ADDENDUM NO. 3:

Date: October 1, 2014
Project: Salvation Army Center of Hope
Owner: The Salvation Army
Architect: Ward Scott Architecture

PROJECT: Salvation Army Shelter	ENG JOB NO# 1374	DATE: Sept. 24, 2014
---	----------------------------	--------------------------------

1 REQ'D CURB/VALLEY GUTTER INSTALLATION TYPICAL SECTION*
NOT TO SCALE

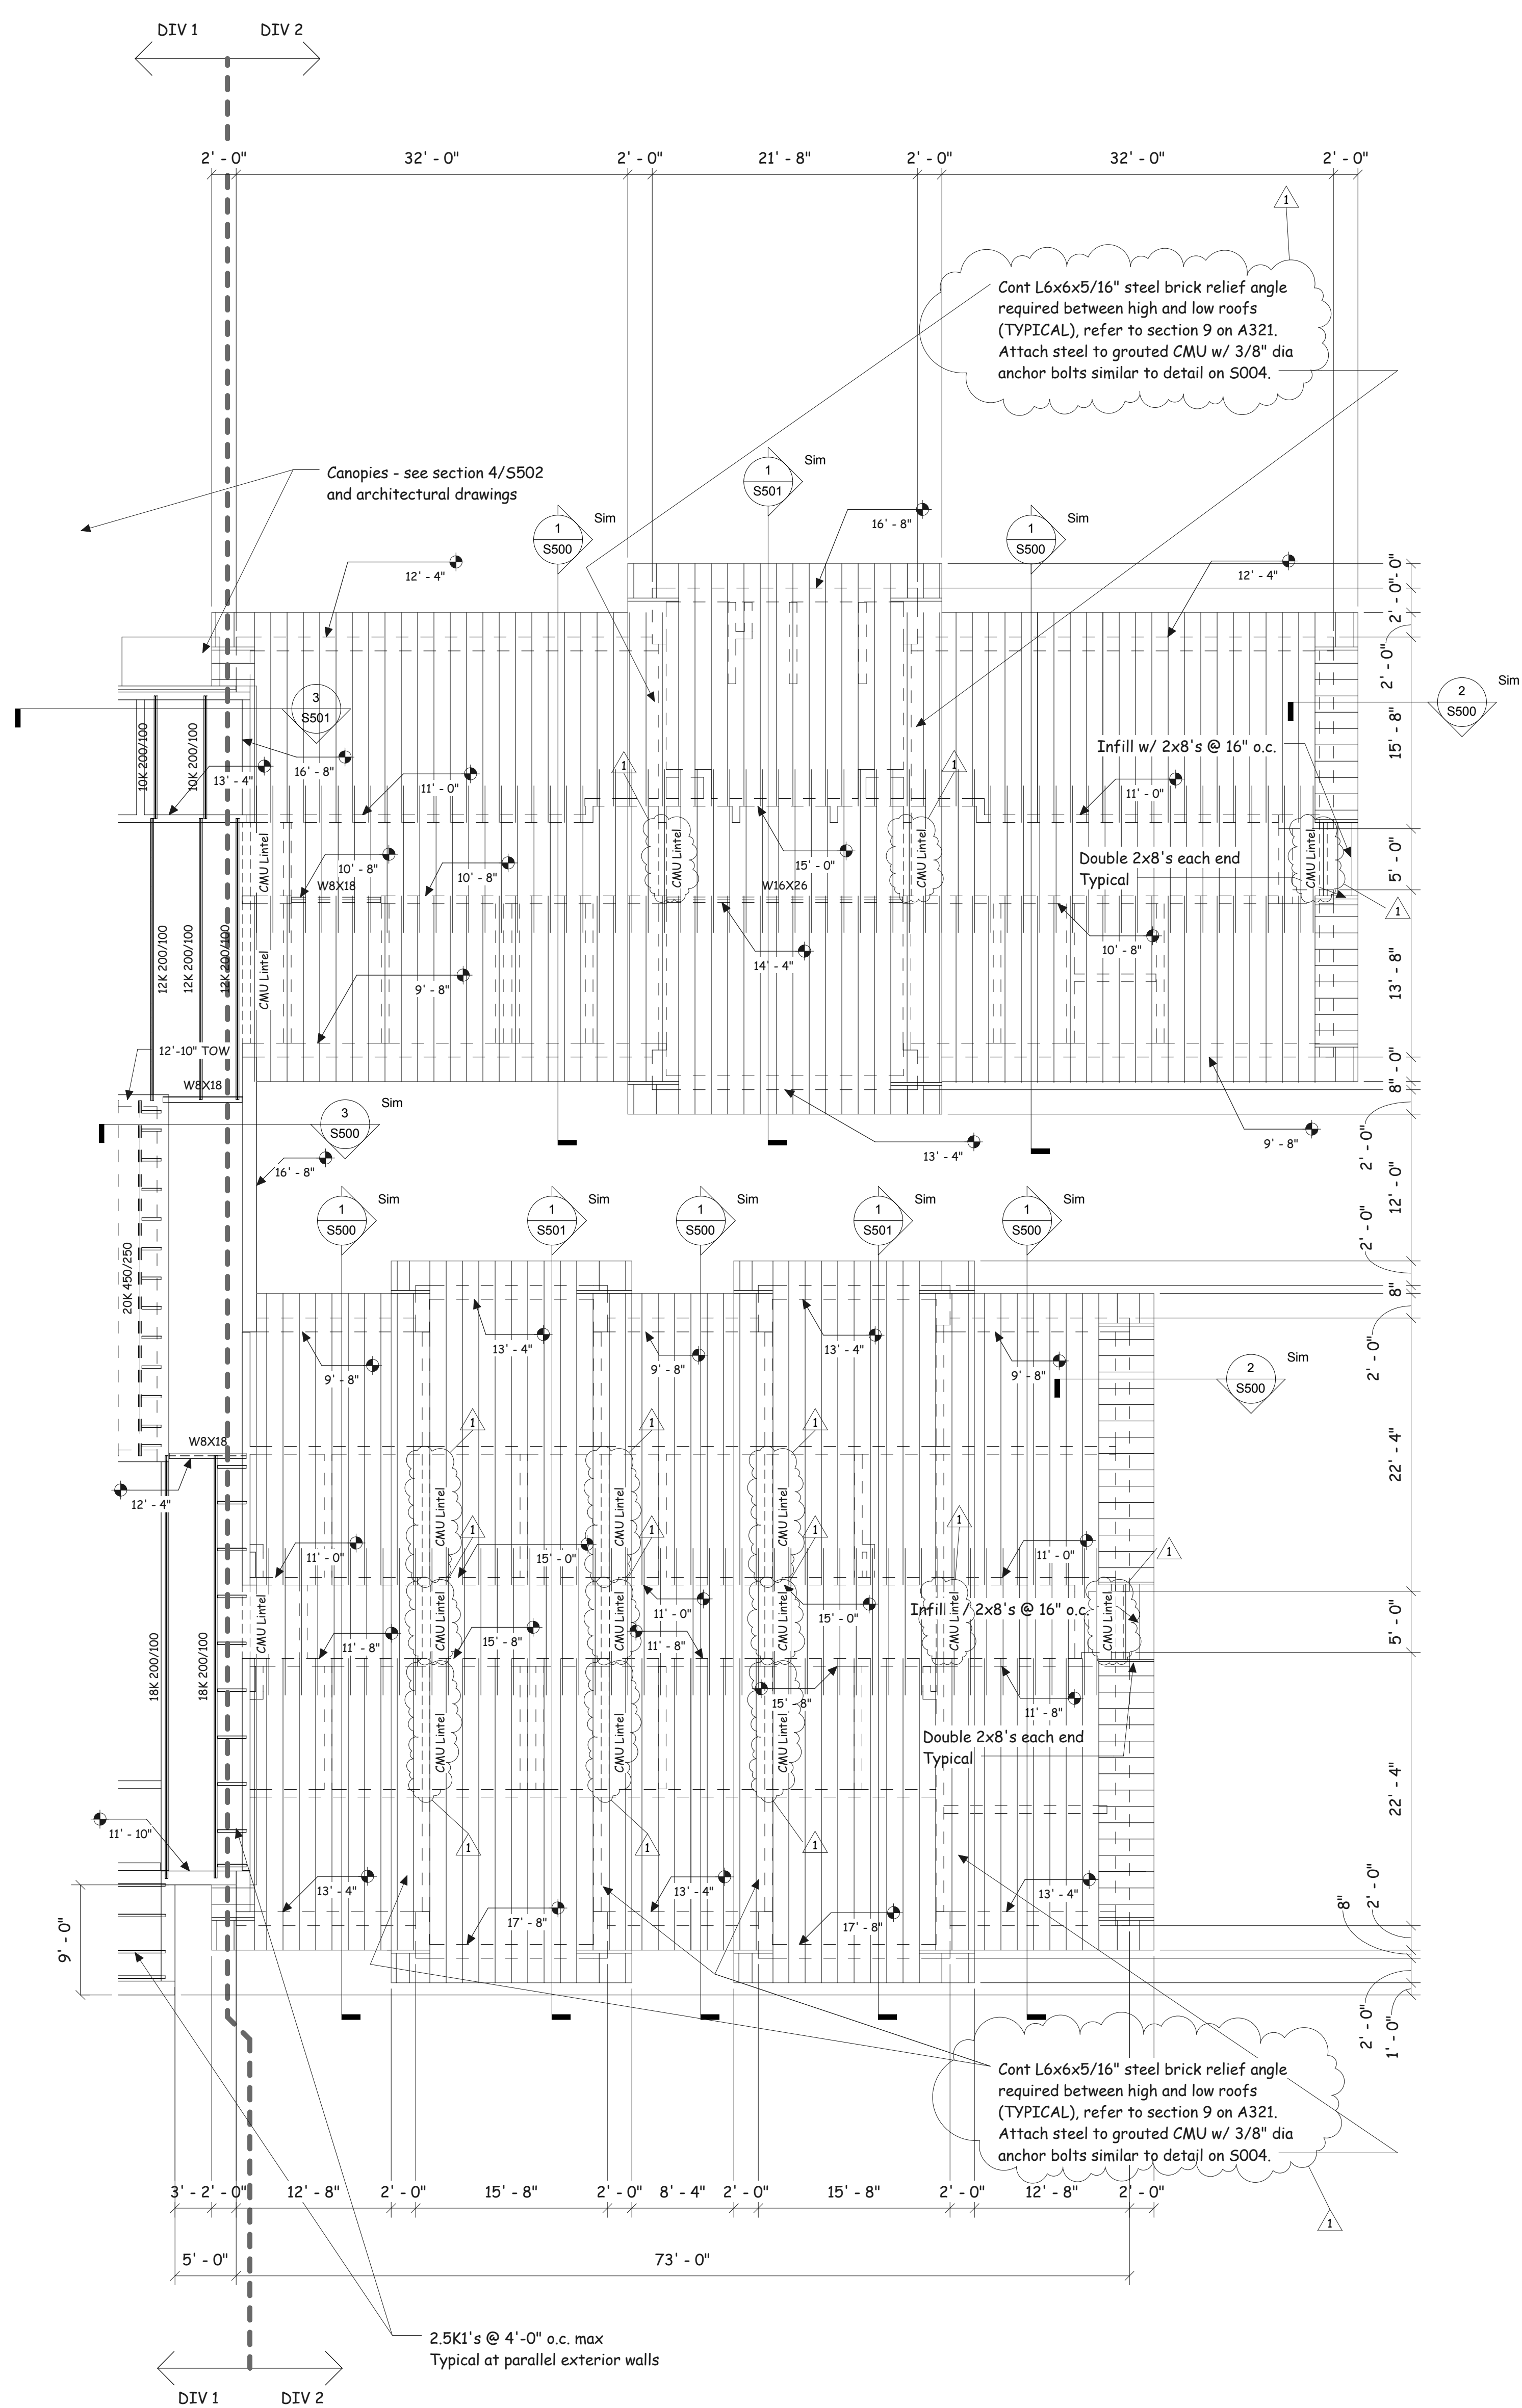
- B. **Civil;** refer to attached supplemental drawing RFI #1; this detail for use in areas where curb or valley gutter are to be installed in close proximity to existing asphalt.

* THIS DETAIL FOR USE IN AREAS WHERE CURB OR VALLEY GUTTER ARE TO BE INSTALLED IN SUCH CLOSE PROXIMITY TO EXISTING ASPHALT THAT PLACEMENT AND COMPACTION OF STONE BASE AS SHOWN ON THE TYPICAL ASPHALT PAVEMENT DETAIL IS NOT POSSIBLE. FOR ALL OTHER AREAS, SEE TYPICAL ASPHALT PAVEMENT DETAIL FOR ASPHALT/STONE BASE THICKNESSES ADJACENT TO CURB OR VALLEY GUTTER.

S302

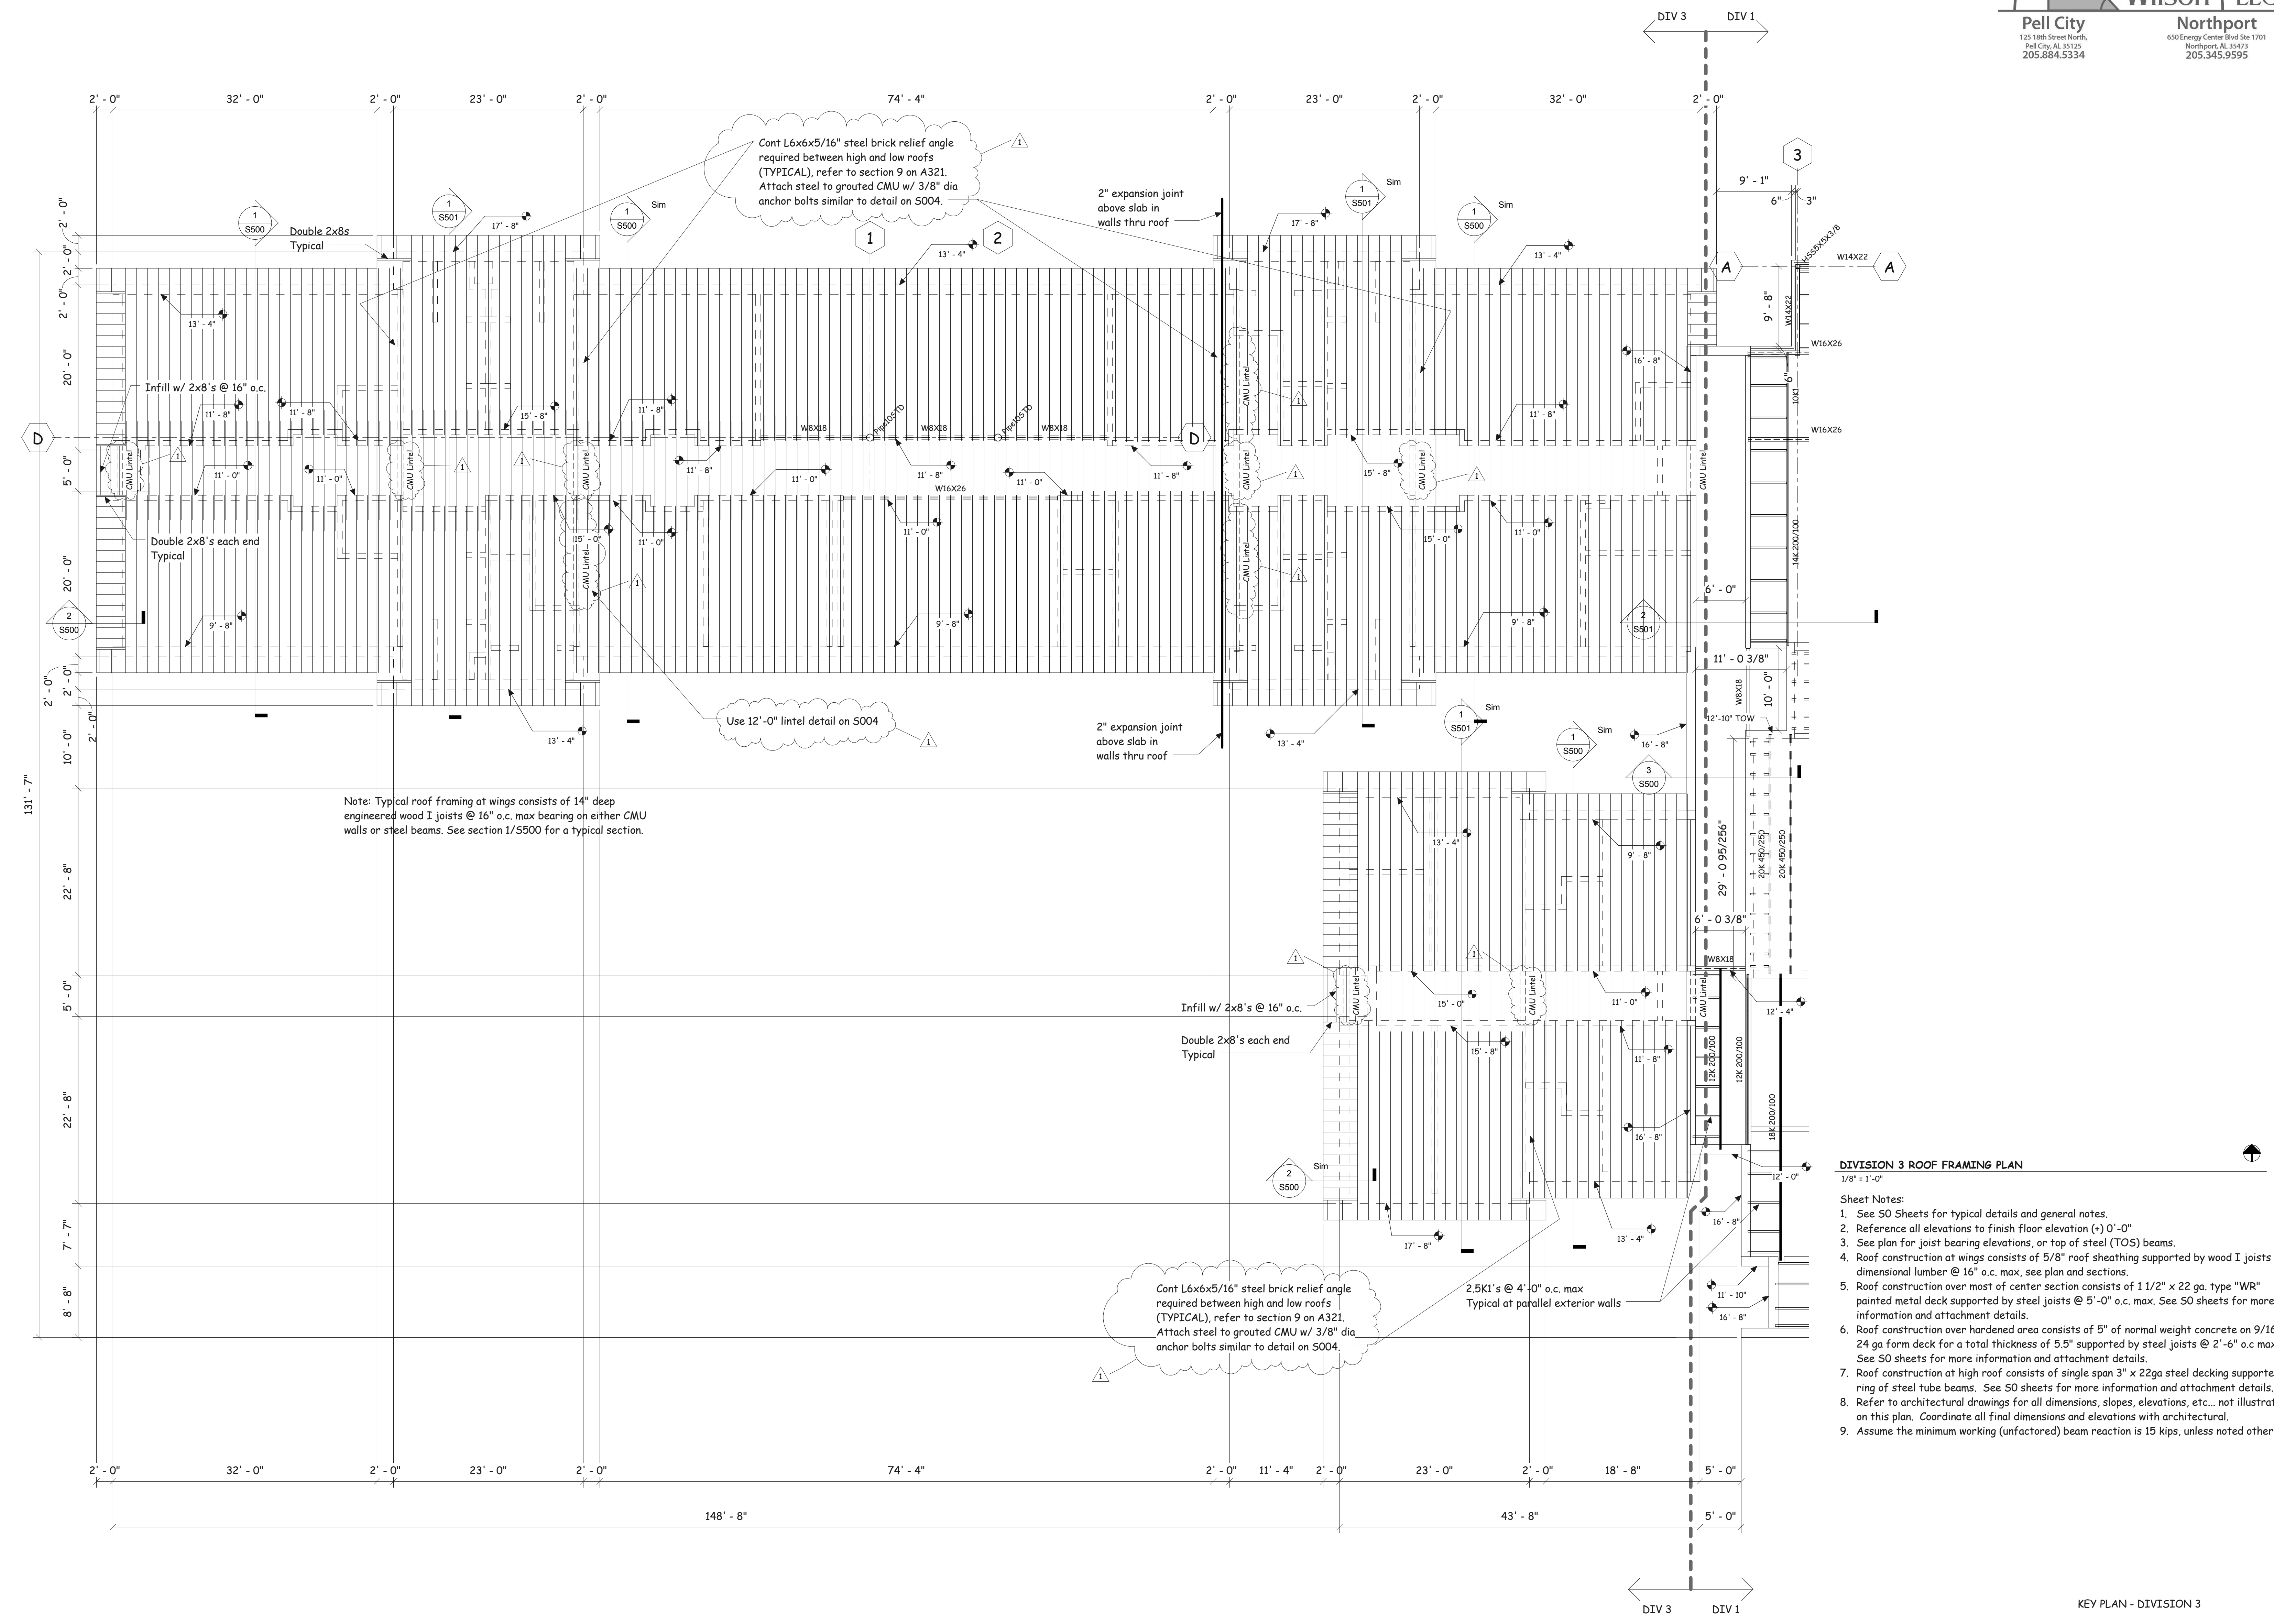
- C. **Sheet S302 & S303; Roof Framing Plans;** replace these sheets with the attached revised sheets.
- D. **Sheet A001; Finish Schedule & Finish Legend;** change all wainscot heights to 7'-8" in lieu of 7'-0". Refer to detail 8/A401 for typical layout and pattern where wainscot occurs.

Cont L6x6x5/16" steel brick relief angle required between high and low roofs (TYPICAL), refer to section 9 on A321. Attach steel to grouted CMU w/ 3/8" dia anchor bolts similar to detail on S004.

Cont L6x6x5/16" steel brick relief angle required between high and low roofs (TYPICAL), refer to section 9 on A321. Attach steel to grouted CMU w/ 3/8" dia anchor bolts similar to detail on S004.

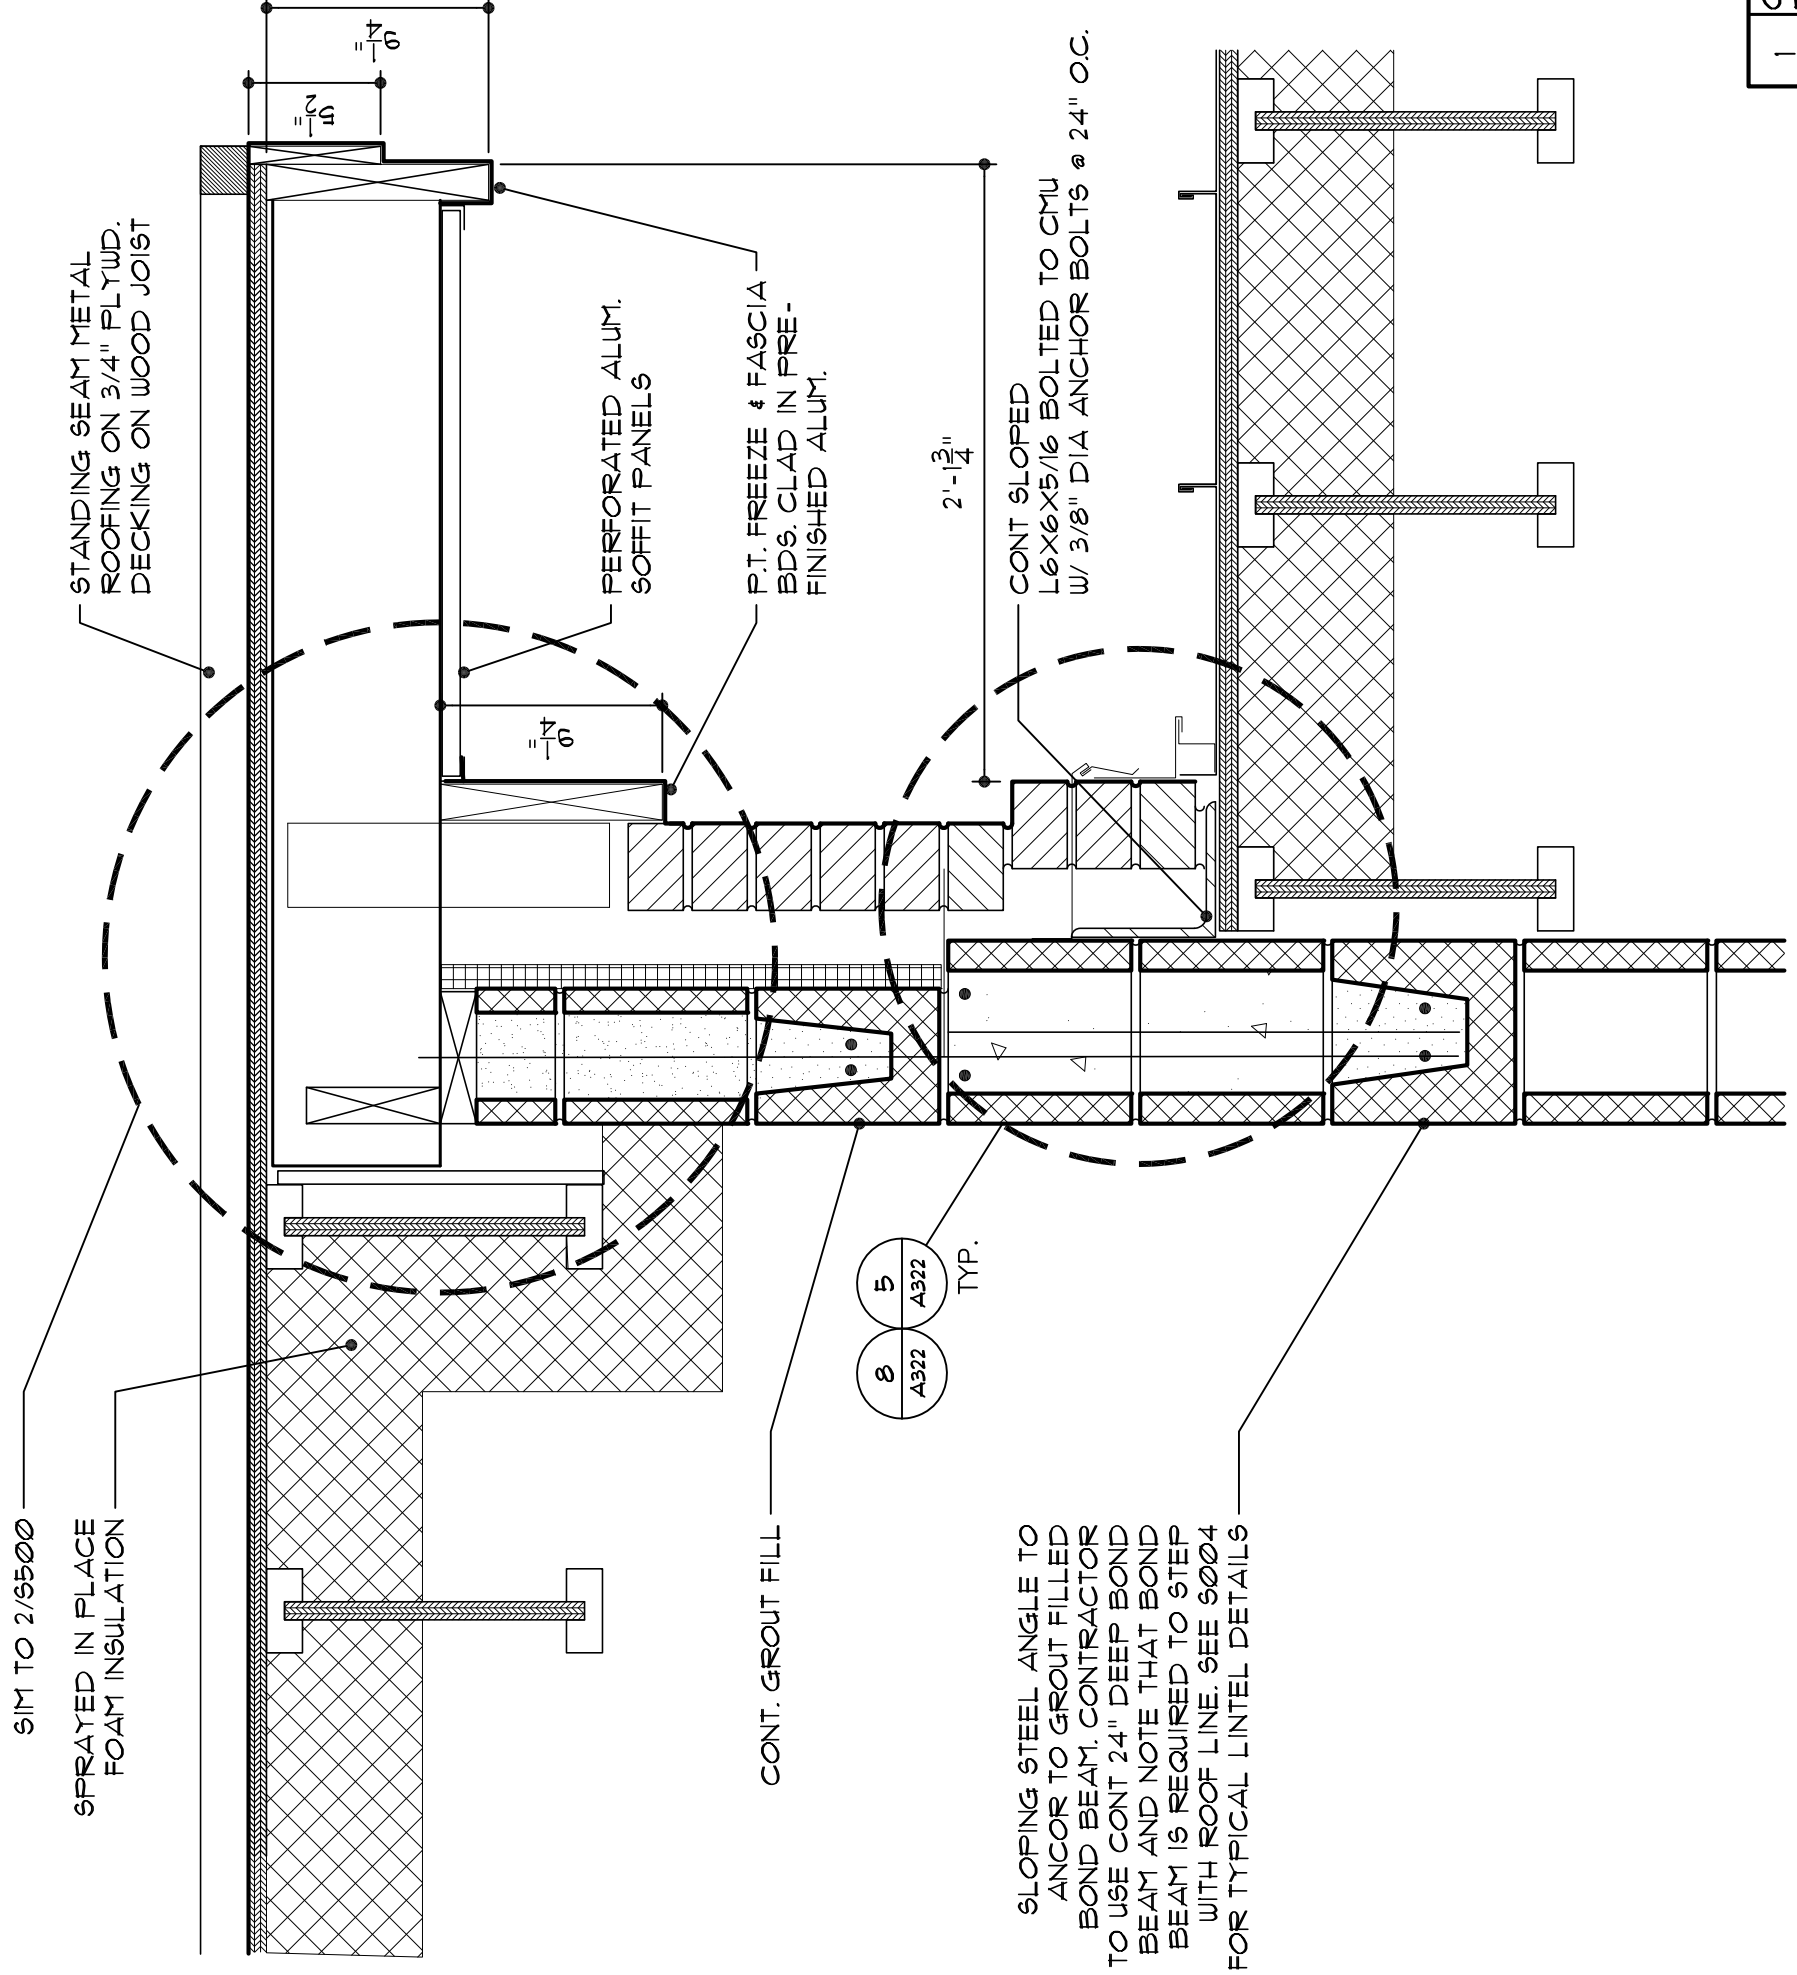
- L. **Sheet A321; Roof Details;** replace detail 9/A321, Overhang Detail with the attached supplemental drawing SD-2.

CONT SLOPED
L6X6X5/16 BOLTED TO CMU
W/ 3/8" DIA ANCHOR BOLTS @ 24" O.C.

SLOPING STEEL ANGLE TO
ANCHOR TO GROUT FILLED
BOND BEAM. CONTRACTOR
TO USE CONT 24" DEEP BOND
BEAM AND NOTE THAT BOND
BEAM IS REQUIRED TO STEP
WITH ROOF LINE. SEE 5004
FOR TYPICAL LINTEL DETAILS
